Access Compliance Report

Public Rights-of-Way

(Curb Ramps)

Intersection ID: 15800	Main Street: PROVIDENCE_RD	Cross Street: QUEENS_RD	Location: SE
ADA ID: D8F4108F0150	Ramp Type: PerpDiag	Initial Pass/Fail: Fail	Overall Compliance: No
Codes/Mitigation Info/Possible Solution		Field Measurements/Component Compliance	
Severity Score: 31.25

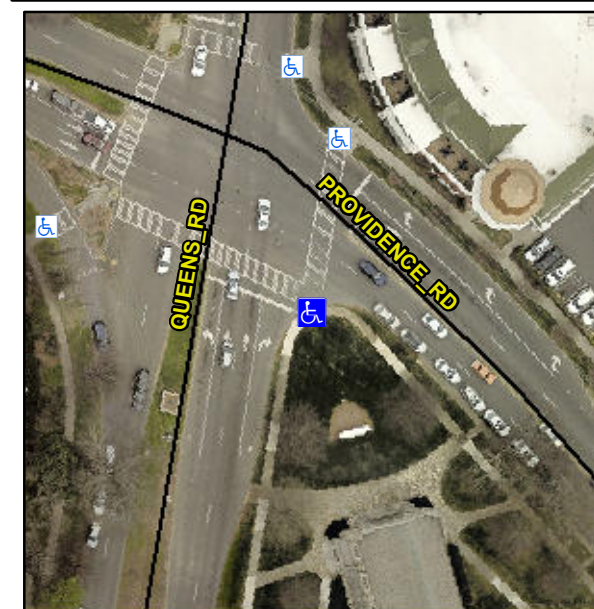
R304.5.1, R304.2.2, R304.5.3

Compliance	Description	Data	Compliance	Description	Data
N/A	Ramp Length (in)	64.0	No	Ramp Slope (%)	9.7
No	Ramp Width (in)	35.0	No	Ramp XSlope (%)	3.1
N/A	Flare Type LT	N/A	N/A	Flare Type RT	N/A
N/A	Flare Slope LT (%)	N/A	N/A	Flare Slope RT (%)	N/A
N/A	Flare Traversable LT?	N/A	N/A	Flare Traversable RT?	N/A
N/A	Landing Length (in)	N/A	N/A	DWS Provided?	N/A
N/A	Landing Width (in)	N/A	N/A	DWS Contrast?	N/A
N/A	Landing Slope (%)	N/A	N/A	DWS Length (in)	N/A
N/A	Landing X Slope (%)	N/A	N/A	DWS Full Width?	N/A
N/A	Landing Curb? (Y/N)	N/A	N/A	DWS Offset (in)	N/A
N/A	Shared Landing?	N/A			
N/A	Gutter Ponding?	N/A	N/A	Gutter Slope (%)	N/A
N/A	Gutter Lip Ht (in)	N/A	N/A	Gutter X Slope (%)	N/A
N/A	Painted X Walk1?	Yes	N/A	Painted X Walk2?	Yes
	X Walk 1 Direction	To NE		X Walk 2 Direction	To NW
N/A	X Walk 1 Width (in)	112.0	N/A	X Walk 2 Width (in)	116.0
	X Walk 1 Slope (%)	4.7		X Walk 2 Slope (%)	2.3
	X Walk 1 X Slope (%)	0.9		X Walk 2 X Slope (%)	4.0

Remove & Replace Curb Ramp With Two New Directional Ramps or Equivalent. Restripe Crosswalk.
